AEP-NRC-2014-24
10 CFR 50.90

Donald C. Cook Nuclear Plant Units 1 and 2
License Amendment Request Regarding a Change to the Reactor Coolant System Pressure and
Temperature Limits

Safety Evaluation of Proposed Changes to Unit 1 and Unit 2 Technical Specification 3.4.3

Figure 3.4.3-1 (page 1 of 1)
Reactor Coolant System Pressure versus Temperature Limits -
Heatup Limit, Criticality Limit, and Leak Test Limit
(Applicable for service period up to 32 EFPY)

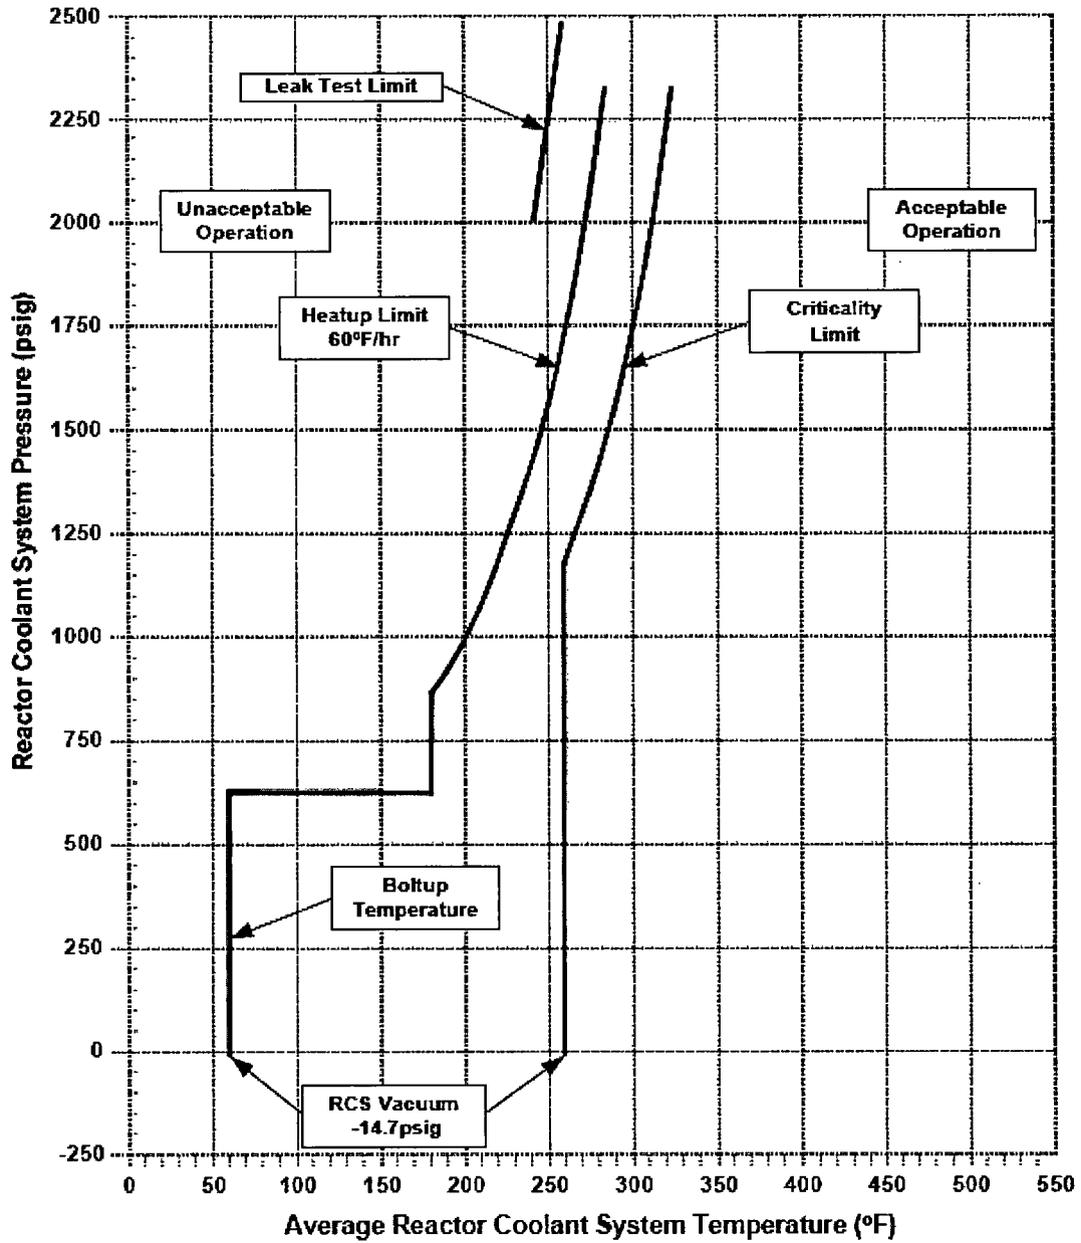
The proposed amendment would revise the CNP Unit 1 and Unit 2 TS 3.4.3, changing Figures 3.4.3-1 "Reactor Coolant System Pressure versus Temperature Limits – Heatup Limit, Criticality Limit, and Leak Test Limit (Applicable for service period up to 32 EFPY)" and 3.4.3-2 "Reactor Coolant System Pressure versus Temperature Limits – Various Cooldown Rates Limits (Applicable for service period up to 32 EFPY)". The proposed changes to these figures would include extending the y-axis (ordinate) below 0 pounds per square inch gauge (psig), as well as extending the curves to -14.7 psig. These changes provide the graphical representation of vacuum conditions, which would be encountered during vacuum fill evolutions

Since the pressure axis for these curves terminates at 0 psig, operation of the RCS in a pressure condition less than 0 psig (e.g. RCS vacuum fill conditions) is not enveloped per the current TS defined P/T conditions.

The proposed changes to TS Figures 3.4.3-1 and 3.4.3-2 are necessary to reflect RCS pressure conditions experienced during RCS vacuum fill operation.

and during vacuum fill

Figure 3.4.3-1 (page 1 of 1)
Reactor Coolant System Pressure versus Temperature Limits -
Heatup Limit, Criticality Limit, and Leak Test Limit
(Applicable for service period up to 32 EFPY)

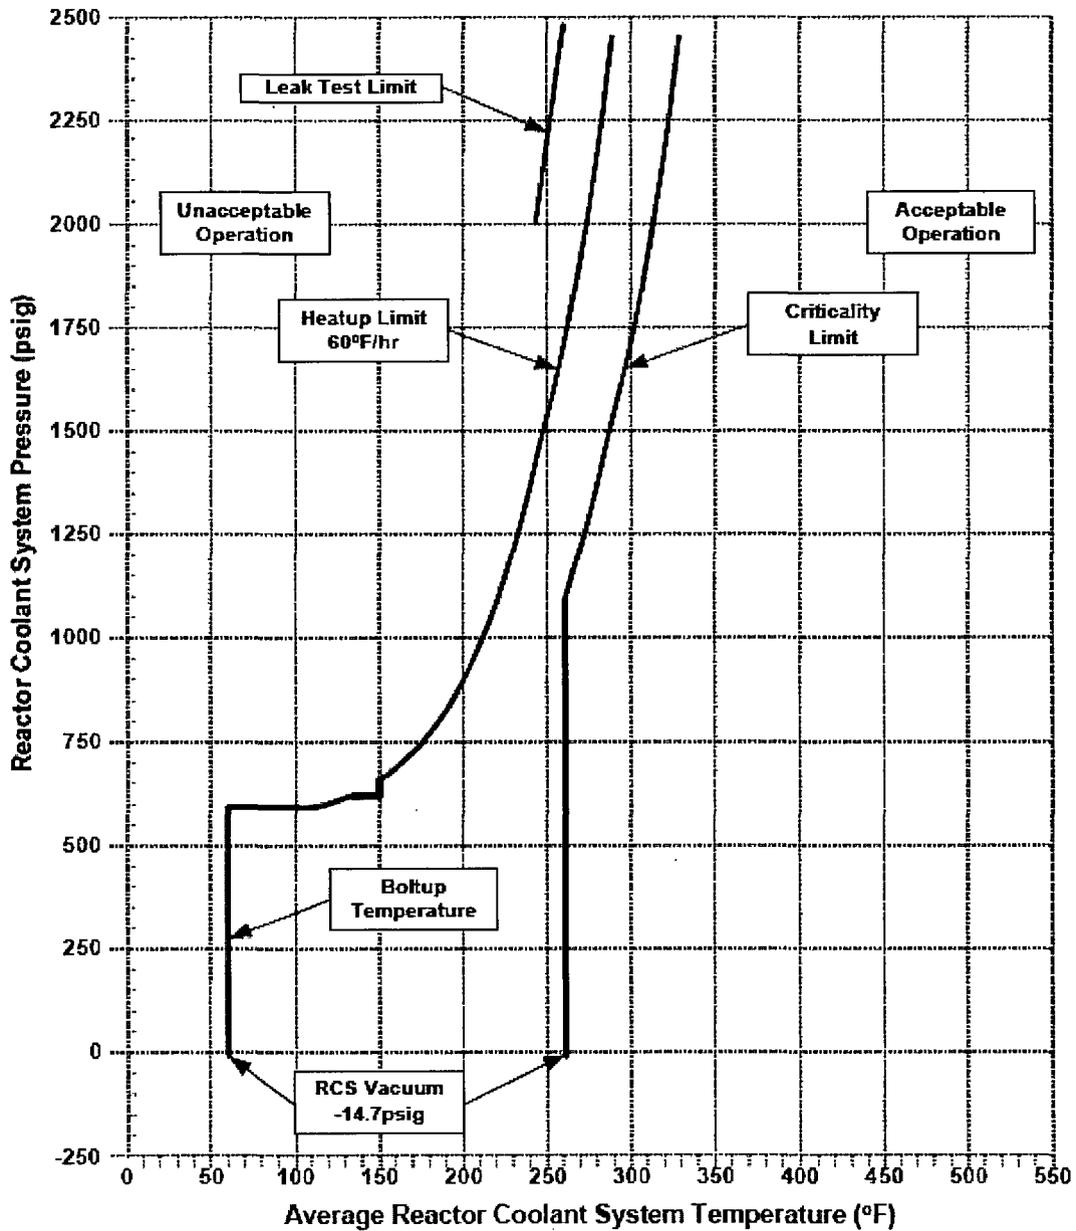
and during vacuum fill

Figure 3.4.3-2 (page 1 of 1)
Reactor Coolant System Pressure versus Temperature Limits -
Various Cooldown Rates Limits
(Applicable for service period up to 32 EFPY)

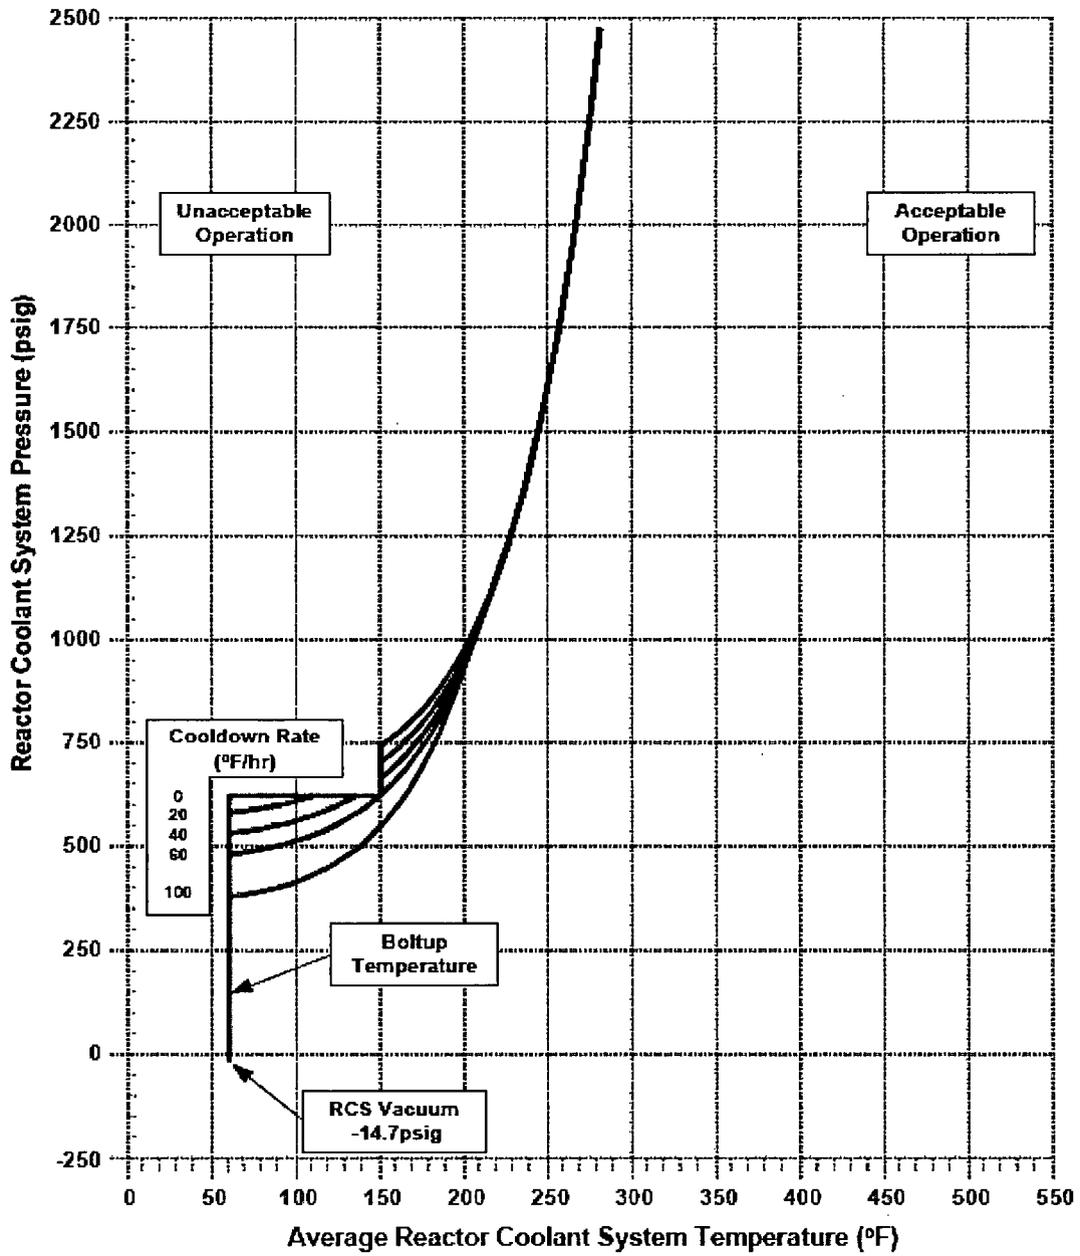
and during vacuum fill
